**Re: Motiv Technical Bulletin for the following recall notices**

- 24V698 (Ring-terminal) non-school bus
- 24V699 (Ring-terminal SB)
- 2024-563 (Ring-terminal / TC)

**RECALL INFORMATION**

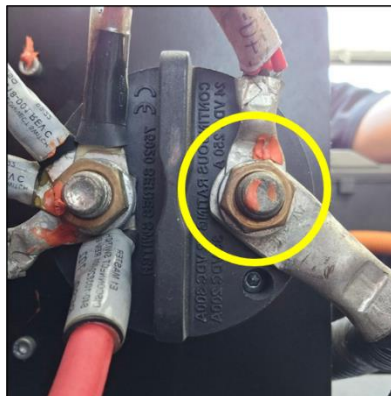
2. Locate wire harness P/N 840-106336-001 that runs from the post on the back - **DRIVER** - side of the master disconnect switch
3. Inspect the junction point of the six (6) wires and ring terminal for the presence of heat shrink.
4. If heat shrink is present and the harness has adequate strain relief, as circled yellow in the picture below, the harness is acceptable.

5. If there is no heat shrink, as circled in yellow in the picture below, the harness must be replaced.

6. To replace the harness

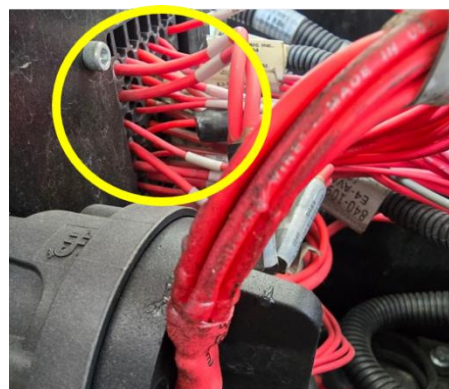
- b. Disconnect the positive lead to the 12v battery
- c. Remove the 13mm nut that secures the ring terminal to the master disconnect switch.

- e. Remove the harness
- f. Reverse steps “b” through “c” to reinstall the new harness
- g. Tighten the nut on the back of the master disconnect switch to 13 ft/lbs.
- h. Turn master disconnect switch on
- i. Test drive vehicle
